From: Julie M. Anderson <jmanderson@longboatkey.org>
Sent: Friday, August 22, 2025 9:02 AM
To: Williams, Molly; Nichols, Brandon
Cc: Cook, Kaleigh
Subject: RE: Norton Street FPL Coordination

For the Norton Street project, we have been working diligently with FPL to come to an agreement on what was permissible for construction on Norton Street. After getting passed between a few FPL folks, we finally got an answer on minimum clearance (see email below).

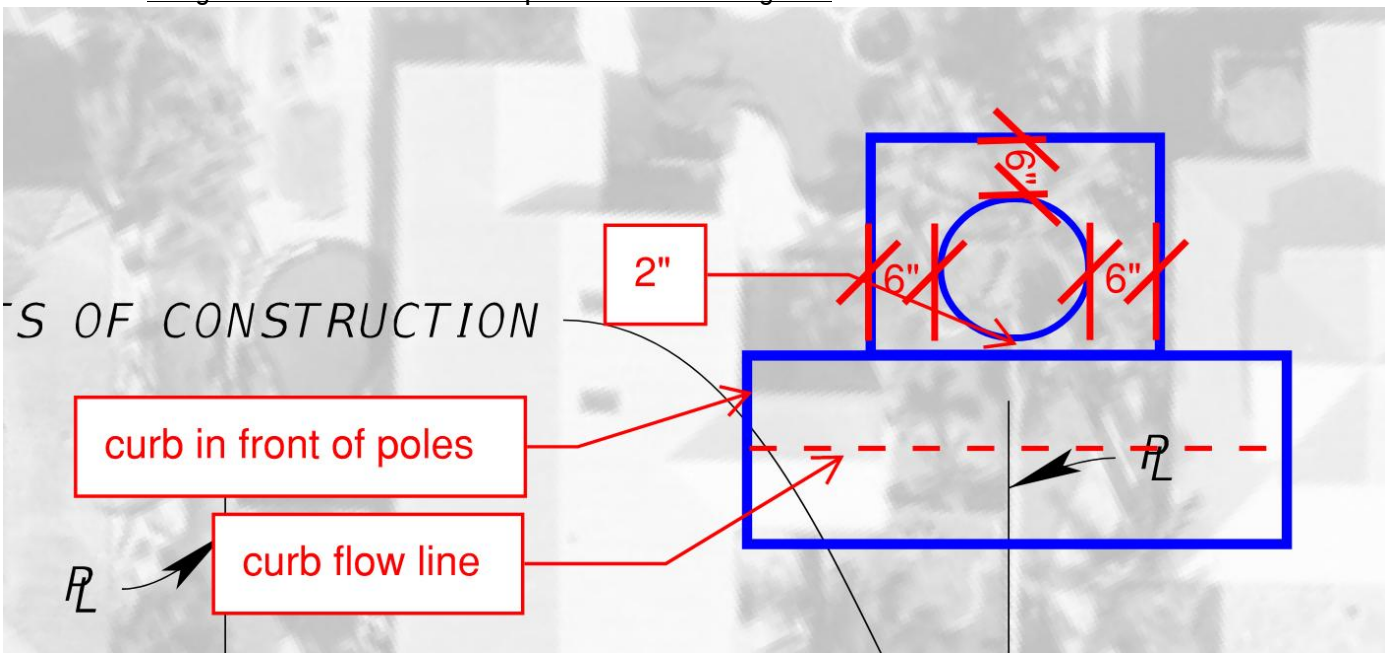
Question #3: Is it permissible by FPL for a 6" by 6" concrete pad to be poured around the light poles to avoid relocation when they are near the proposed gutter? Please see image below for further detail.

- Langston to coordinate a response with colleagues.
